2025 Infrastructure Design & Construction Standards Revision (IDCS)

Board of County Commissioner Study Session October 28, 2025

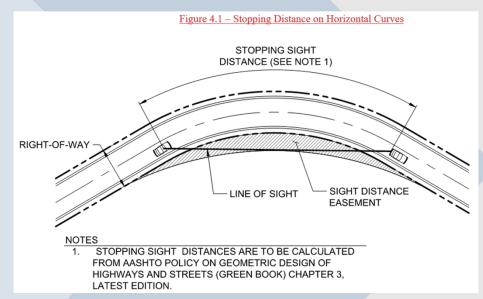
- Updated pavement restoration for all street cuts permits
- Updated how the collateral amounts are established
- Adds back in Survey Control requirements
- Updates to as built and digital file requirements
- Clarifies Subsurface Underground Engineering (SUE) Requirements for Utility Construction Plans
- Further defines Clear Sight Distances for intersections and horizontal curves

Sight Distance
